**RE: Variance Request Article 17, Section 8-301(b) Buffer Disturbance
LINDAMOOD ON THE SEVERN, P/O LOT 6 & ACCRETION LAND**
1829 Cove Point Road
Annapolis, Maryland 21401
Tax Account #02-485-11240900

VARIANCE PLAN
LINDAMOOD ON THE SEVERN, p/o LOT 6
 1828 COVE POINT ROAD, ANNAPOLIS, MD 21401
 TAX ACCT. NO. 02-485-11240900 PERC NO. T02047132 GRADING PERMIT NO. G02018357
 TAX MAP 45F GRID 08 PARCEL 100 DISTRICT 2nd
 ANNE ARUNDEL COUNTY, MARYLAND

Subject: Lindamoor on the Severn, P.O lot 6 and accretion land
1829 Cove Point Road, Annapolis MD 21401
Variance request: 2023-0130-V

EXISTING CONDITIONS SITE OUTFALL "A" DRAINAGE AREA MAP
SCALE: 1"=40'

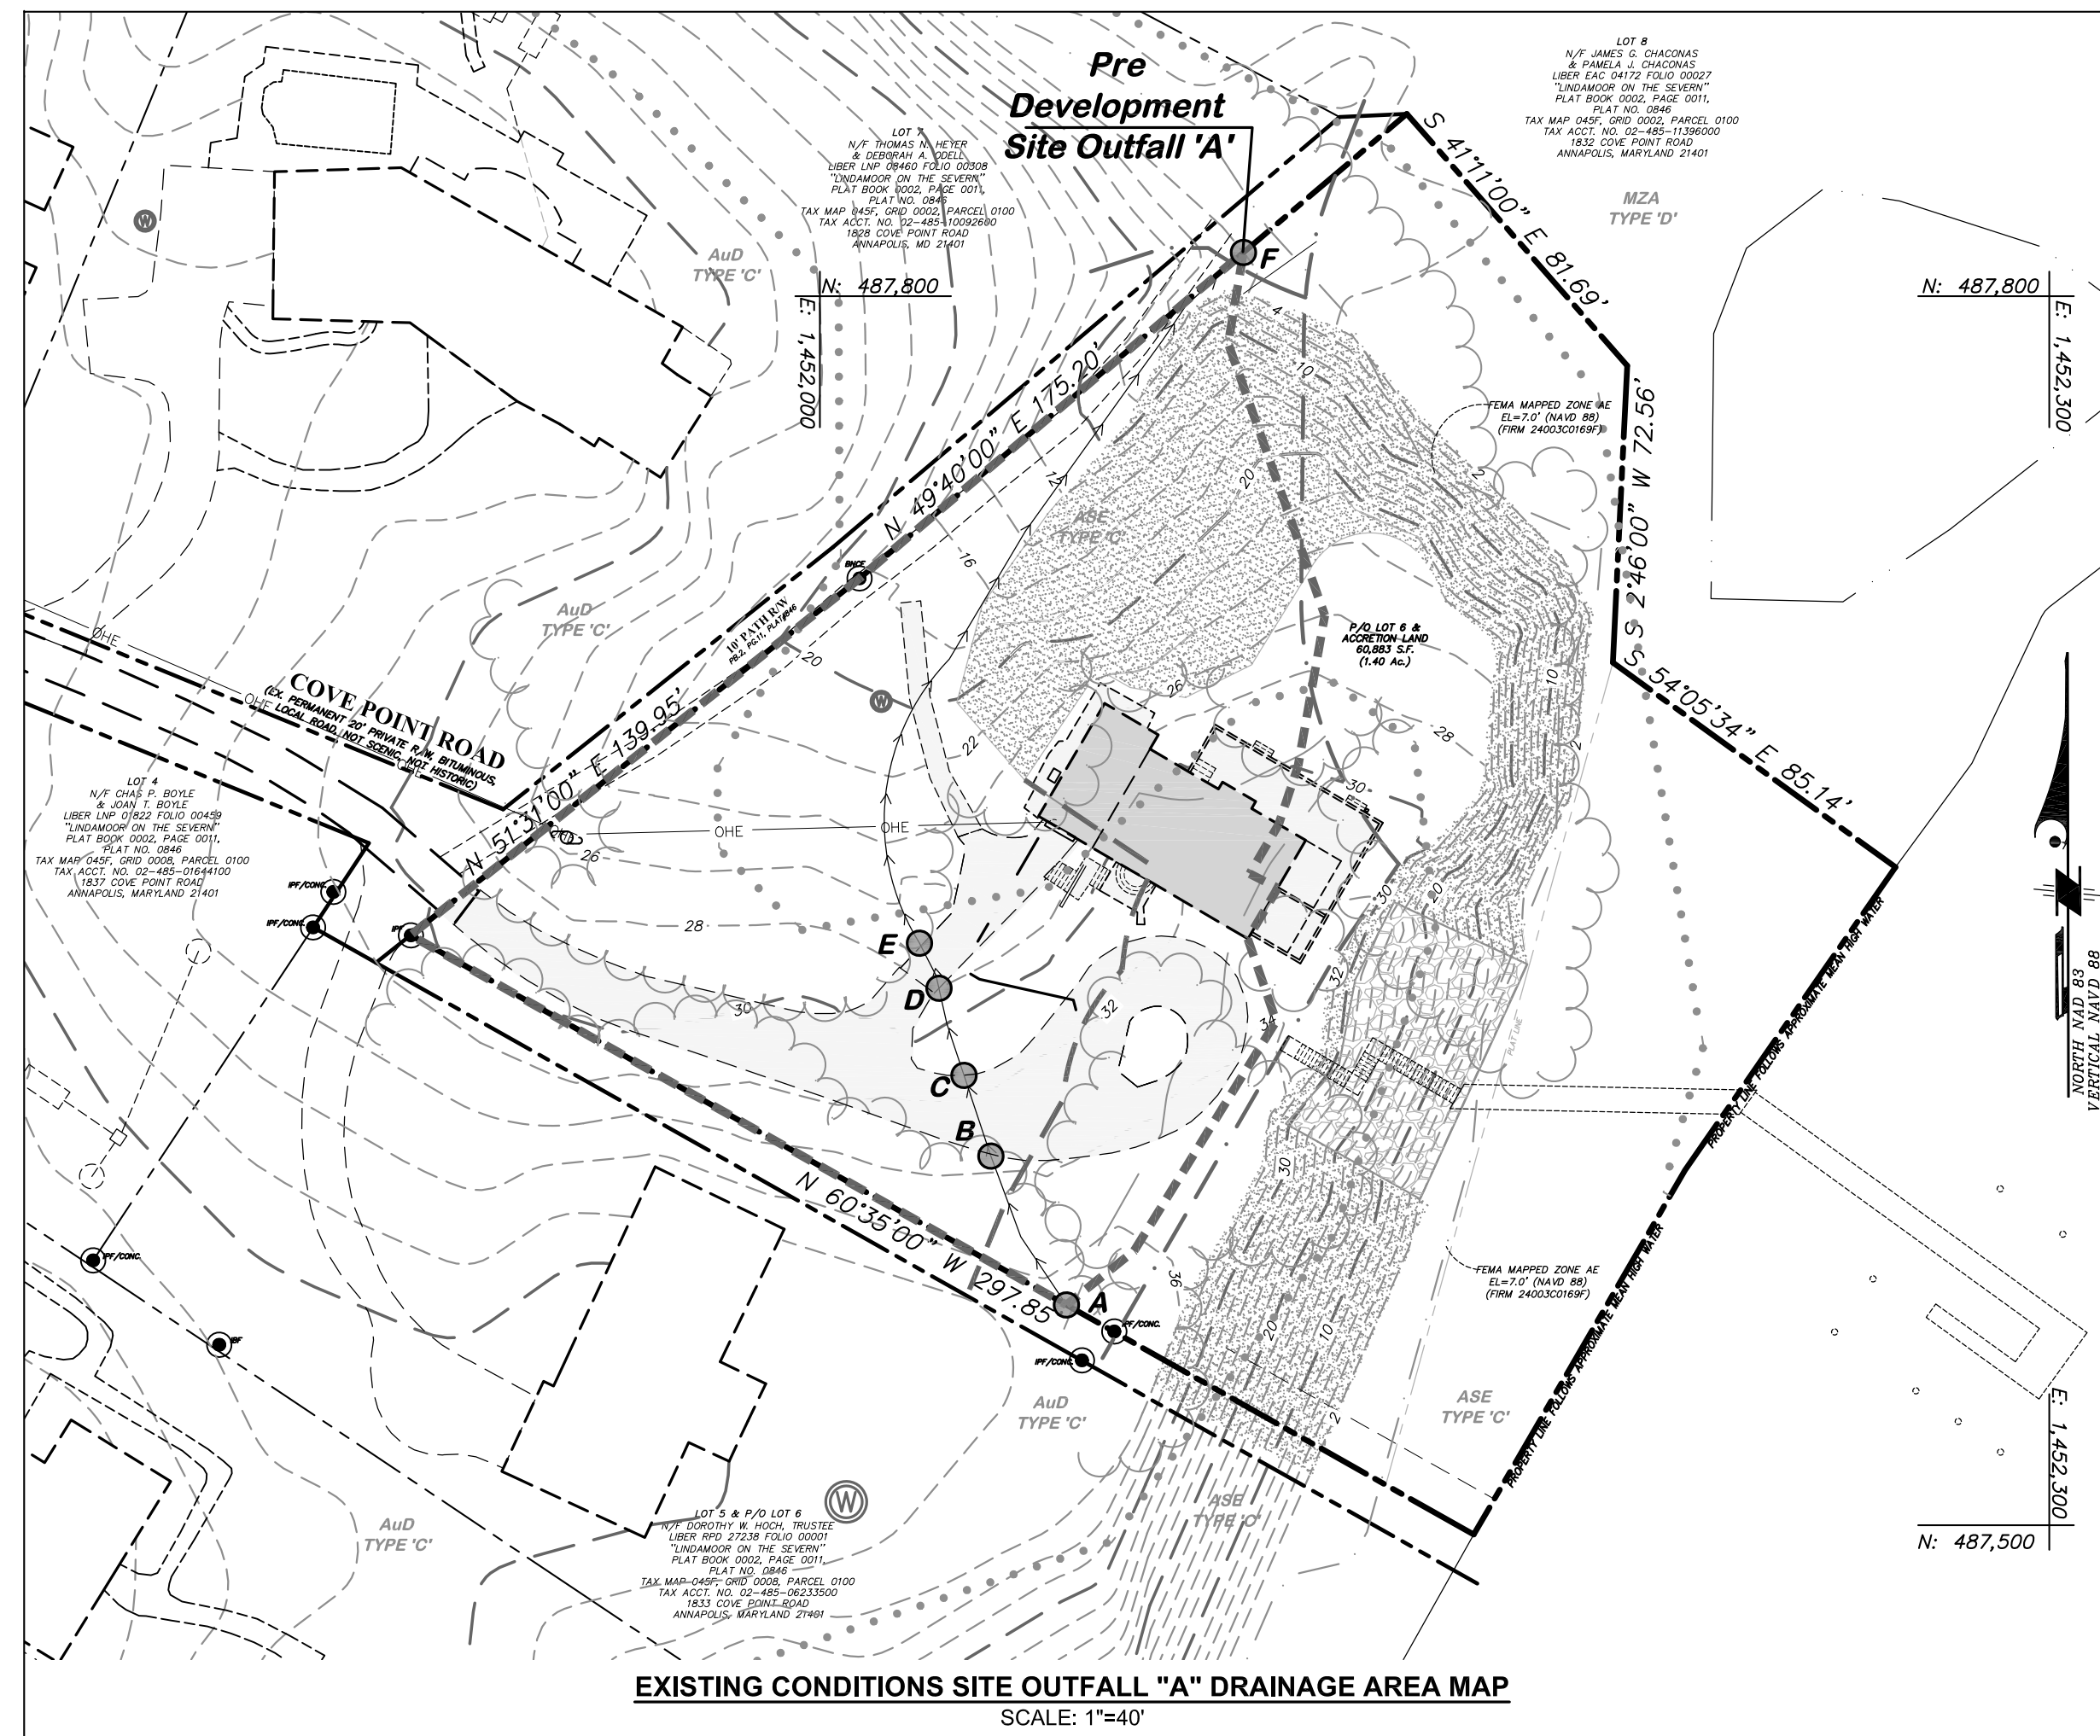
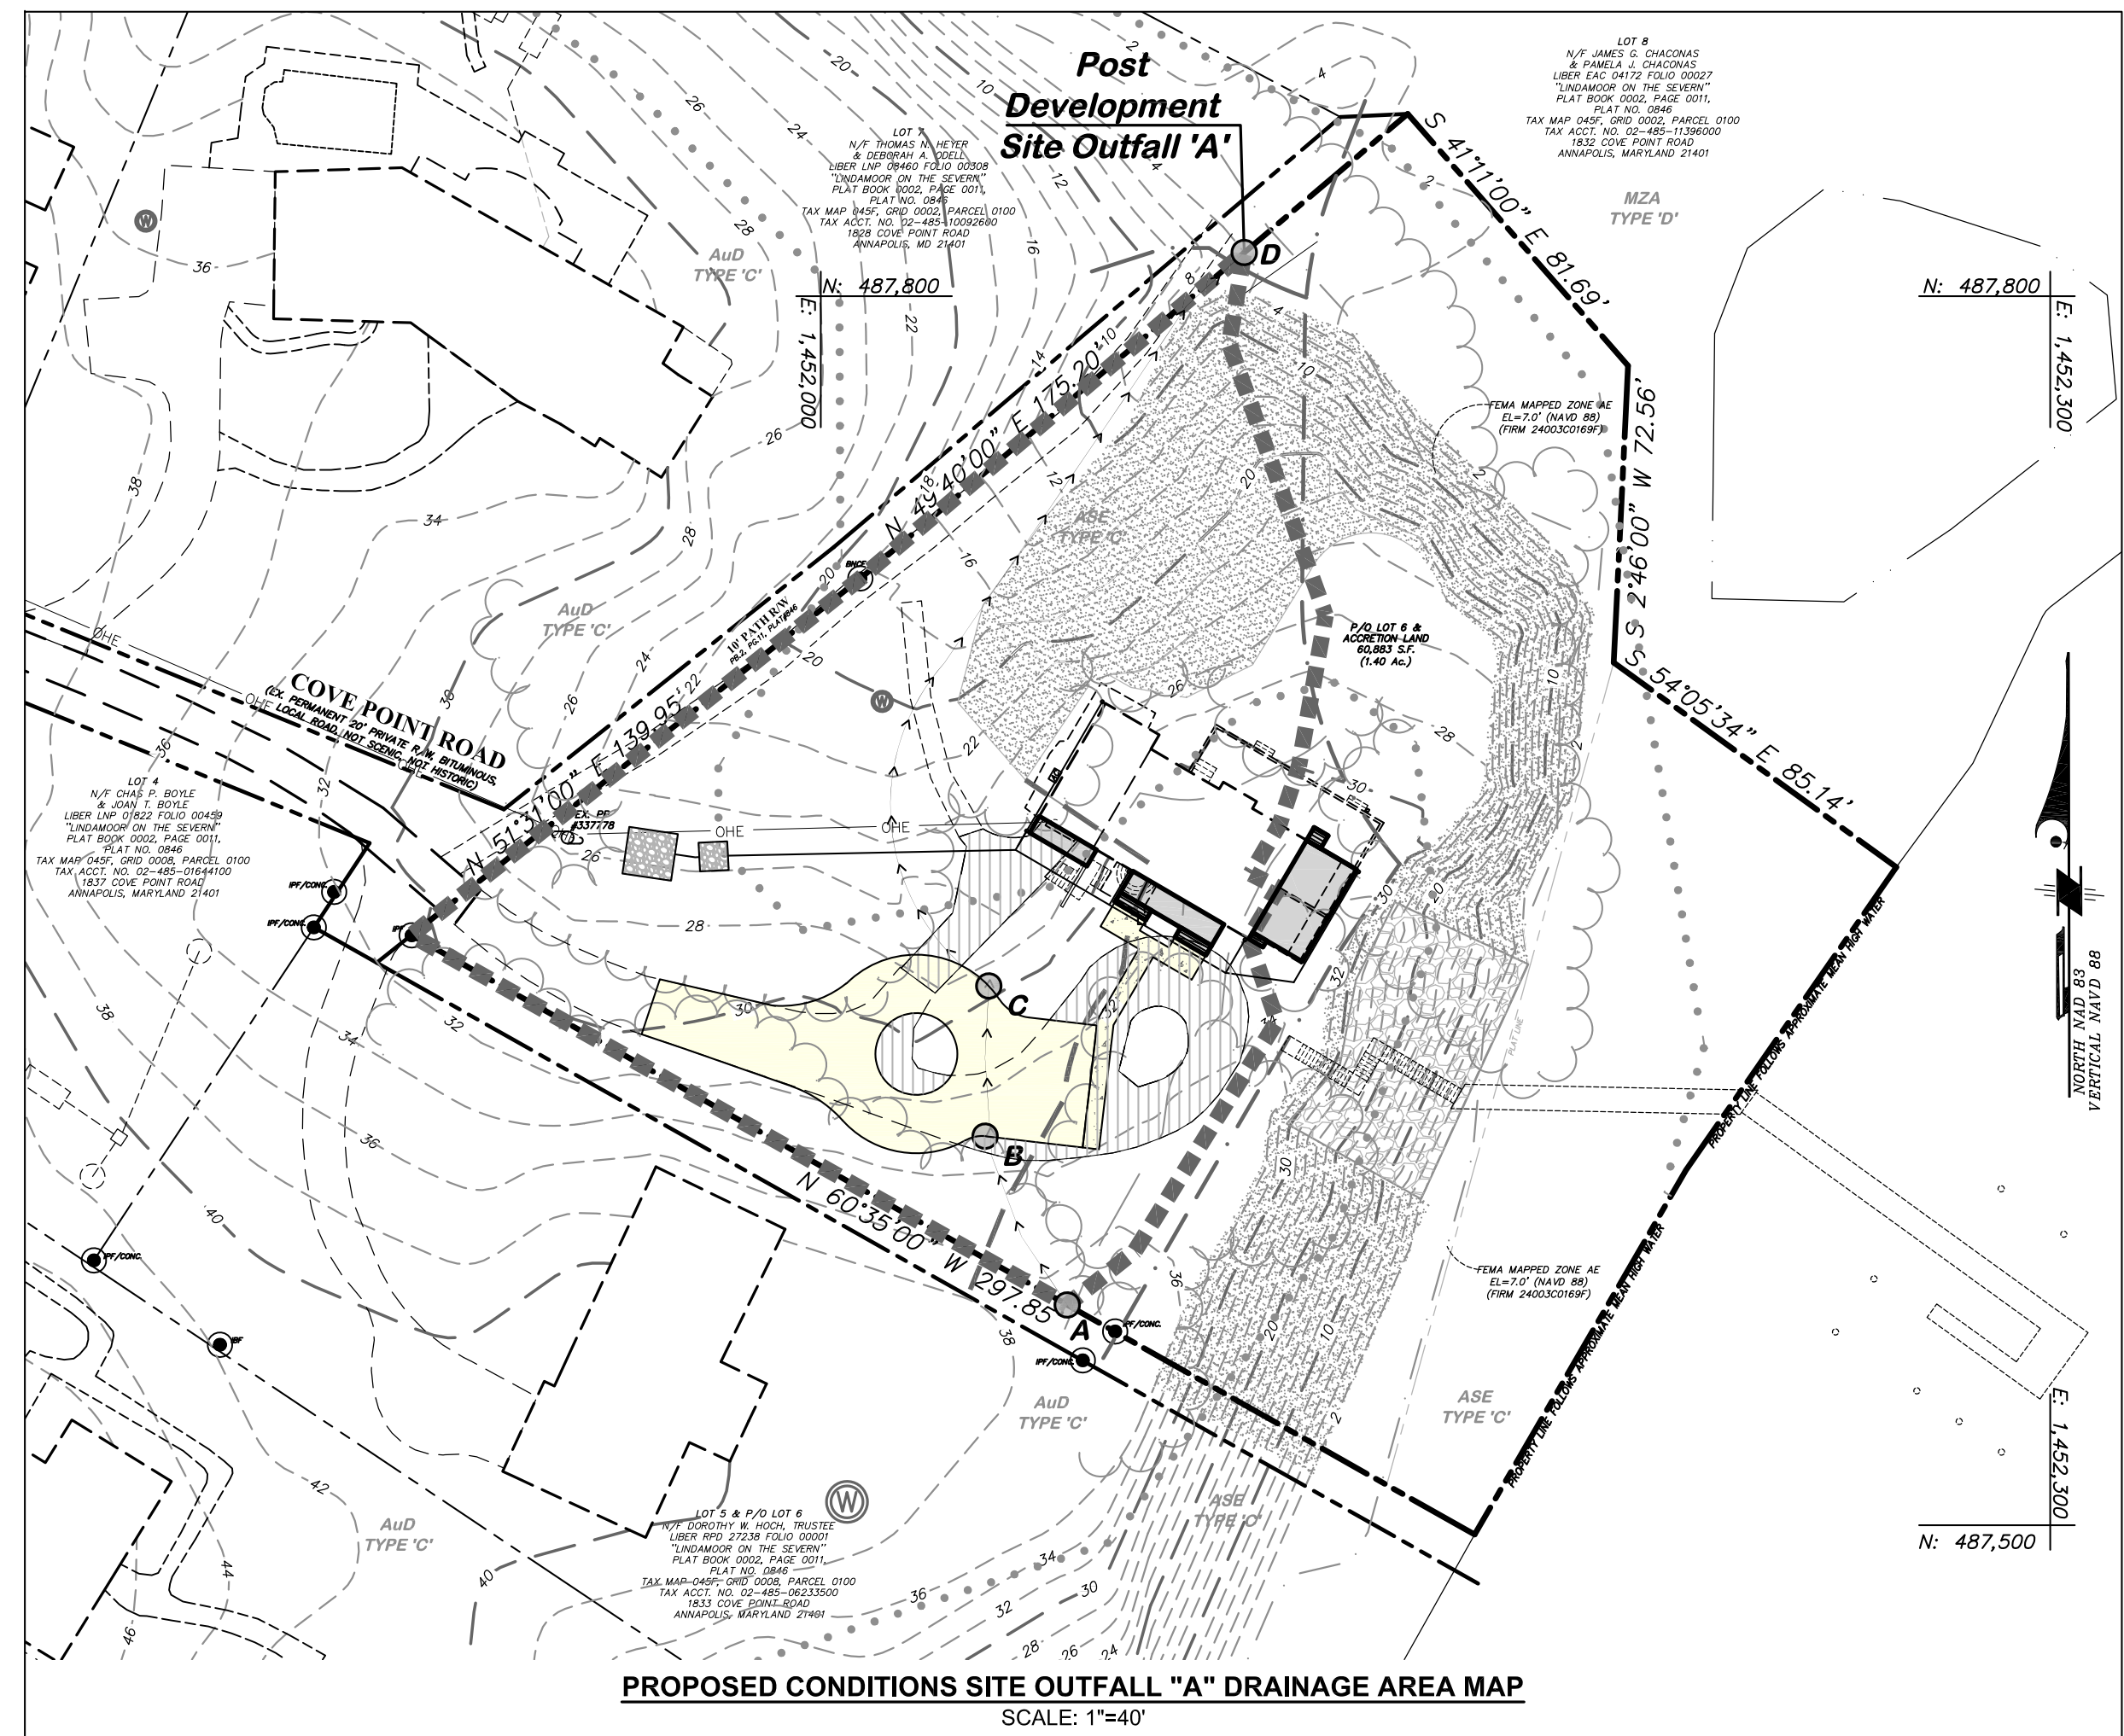
- 2- Existing and proposed drainage area maps are required with the variance application. The site outfalls (all points where proposed drainage leaves the property) must be marked clearly on the plan.
